FINAL PLAT

NORTHEAST ELEMENTARY SCHOOL ADDITION

RE: SUB 2002-71 -- One-Step Final Plat of Northeast Elementary School Addition

STAFF REPORT

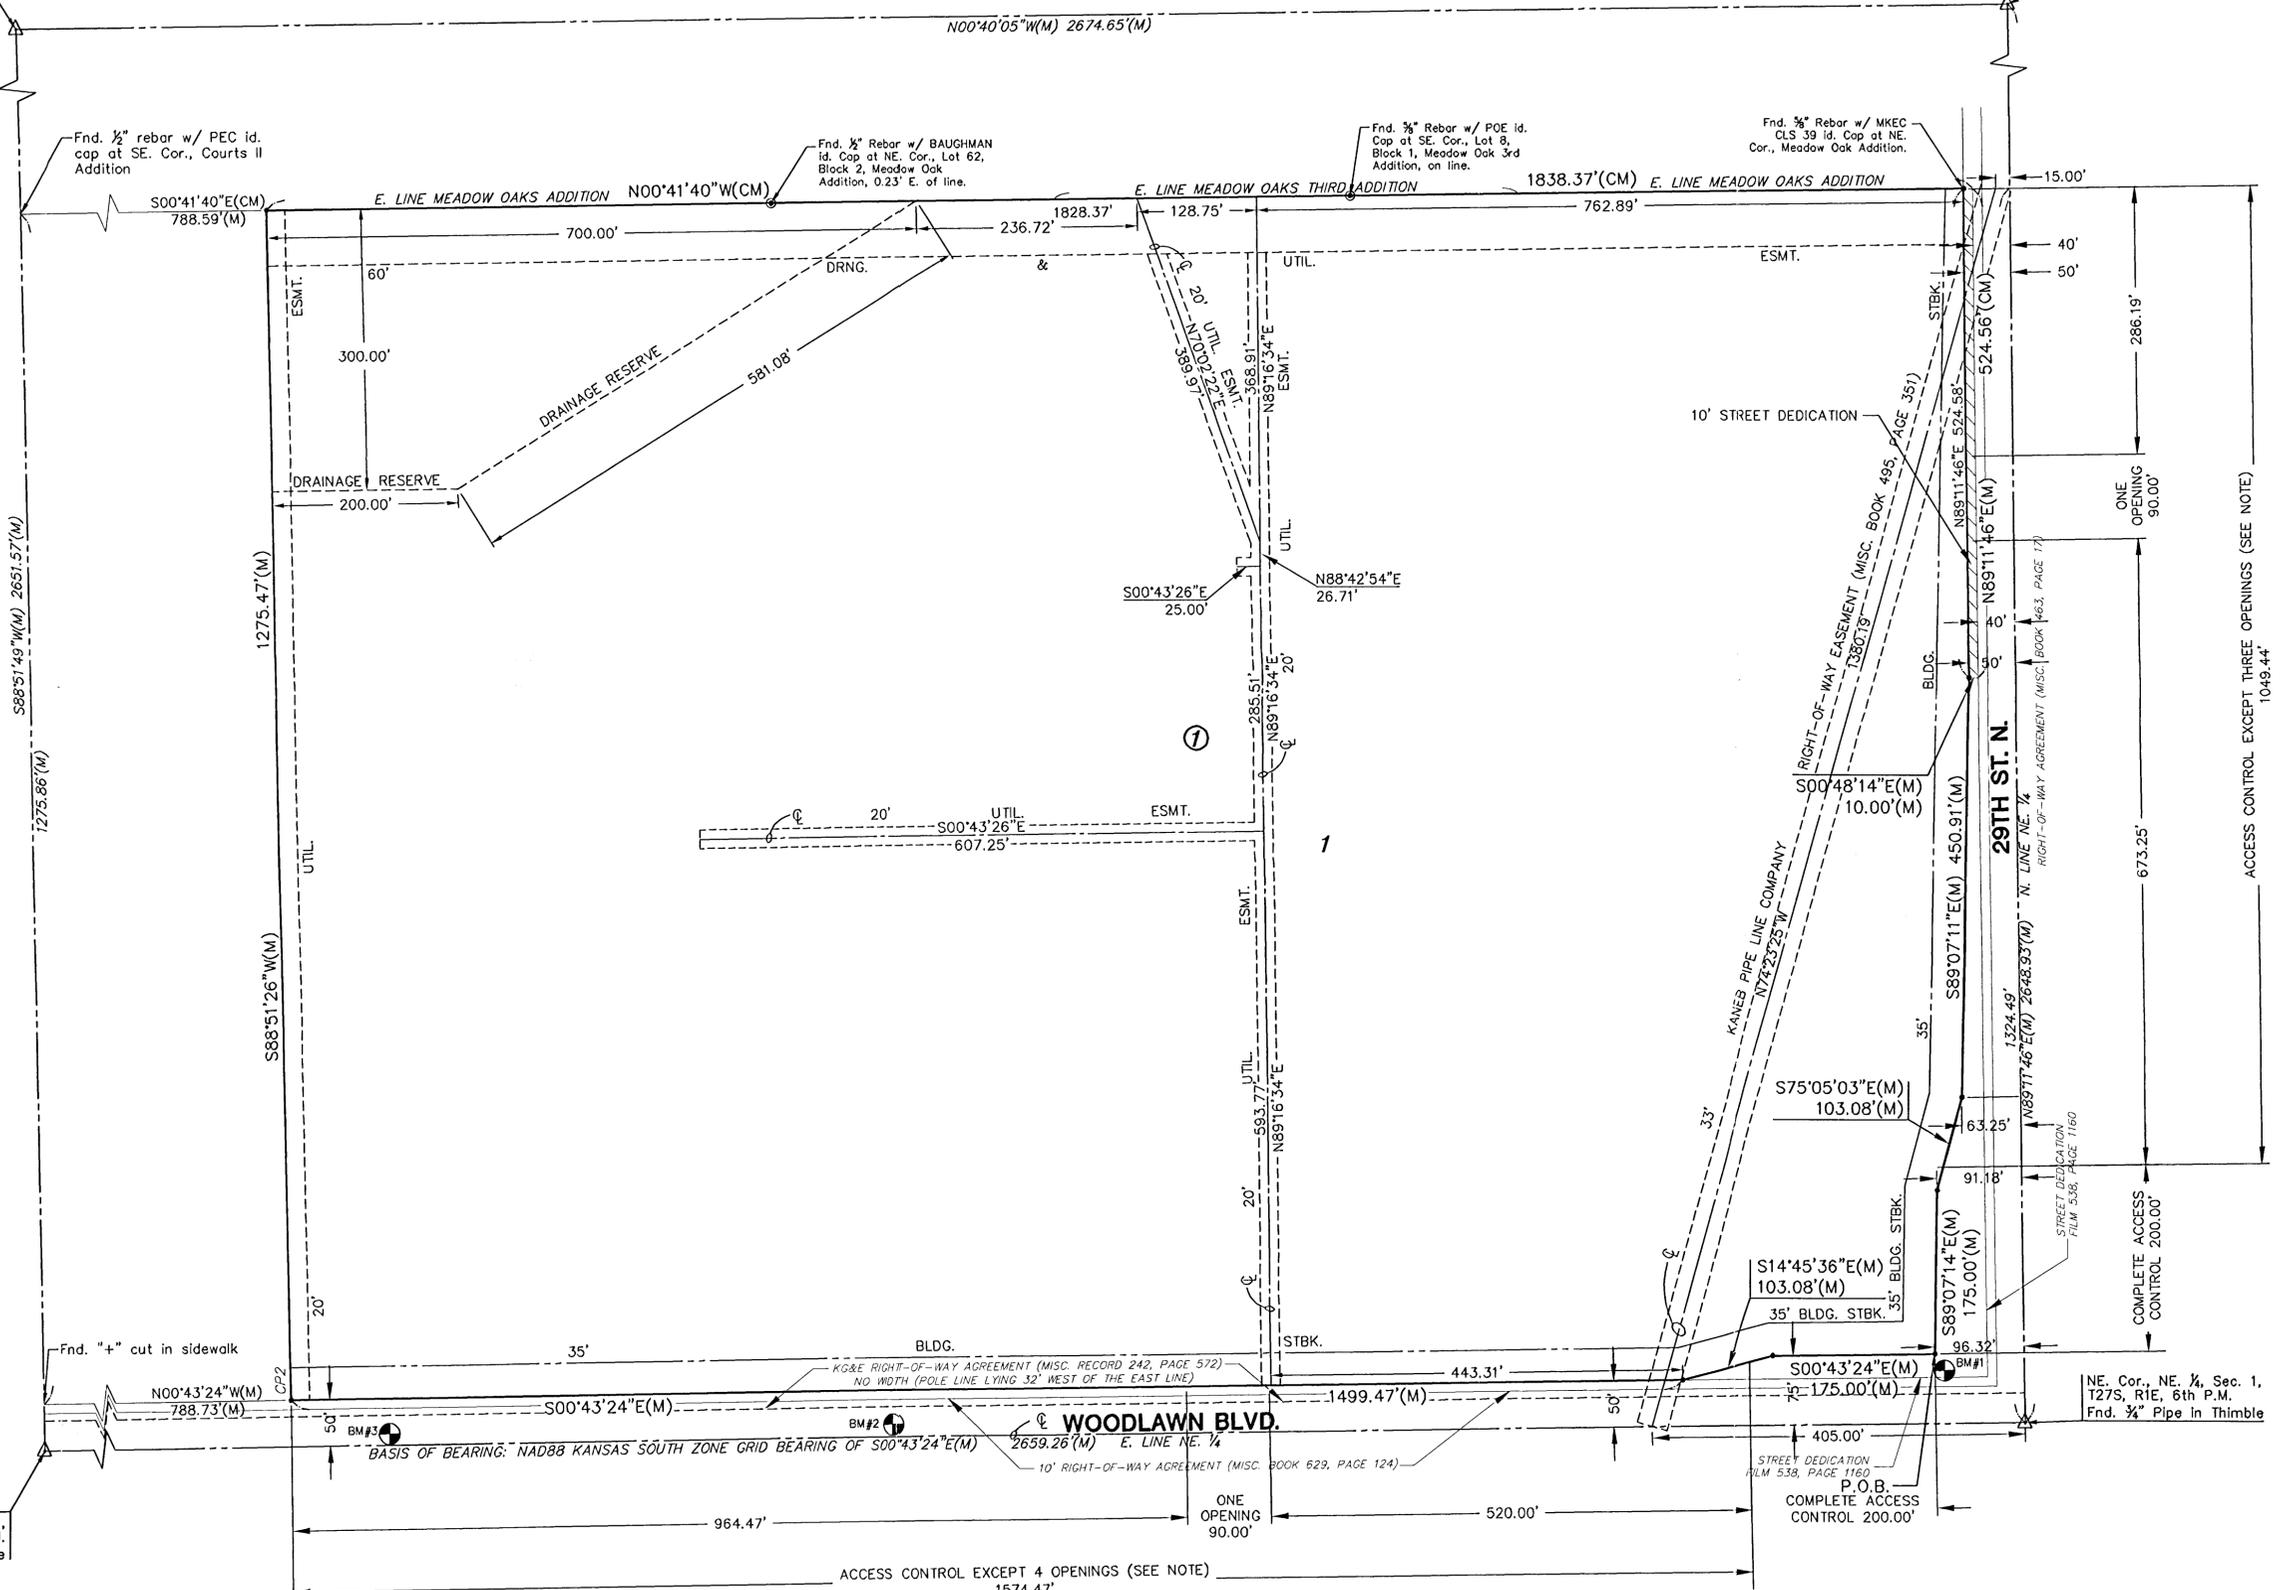
- C. The platting of minimum building elevations should be noted on the face of the plat and referenced in the platting text.
- D. City Engineering needs to comment on the status of the applicant's drainage plan. A drainage reserve is needed in the southwest corner of the site. An off-site drainage easement is also needed.

- E. Traffic Engineering needs to comment on the access controls. The plat proposes four access openings along Woodlawn and three openings along 29th St. North. Distances should be shown for all segments of access control. The first opening with full turning movements along Woodlawn shall align with Pepperwood Road across Woodlawn. Spacing shall be 400 feet between the two subsequent openings; however the southernmost opening shall be at least 400 feet from the existing opening on the adjacent property to the south. Two openings are permitted along 29th St. North. The first opening with full turning movements along 29th St. North shall be at least 400 feet from the intersection; the second opening shall align with the existing opening across 29th St.

- F. Traffic Engineering needs to comment on the need for improvements to perimeter streets. Traffic Engineering has required a petition for left turns at the entrances from Woodlawn. Signalization may be required upon further review by the Traffic Engineer.

- G. The applicant shall submit a copy of the instrument which establishes the pipeline easements on the property, which verifies that the easements shown are sufficient and that utilities may be located adjacent to and within the easements. Any relocation, lowering or encasement of the pipeline, required by this development, will not be at the expense of the City.

- H. The applicant's agent shall determine any setback requirements for the pipelines by researching the text of the pipeline agreements. If a setback from the pipeline easements is provided for in the pipeline easement agreements, it shall be indicated on the face of the plat.

Woodlawn Boulevard – Four access points to Woodlawn are allowed. The minimum distance between full turning movement drives shall be 400'. The minimum distance between a right-in/right-out drive and either another right-in/right-out drive or a full turning movement drive shall be 200'. The northern most full turning movement drive shall align with Pepperwood Road on the east side of Woodlawn as indicated on the face of plat.

29th Street North – Three access points to 29th are allowed. The minimum distance between full turning movement drives shall be 400'. The minimum distance between a right-in/right-out drive and either another right-in/right-out drive or a full turning movement drive shall be 200'. The first opening with full turning movements shall be a minimum distance of 400' from Woodlawn. The second opening from Woodlawn shall align with the existing drive on the north side of 29th Street as indicated on the face of plat.
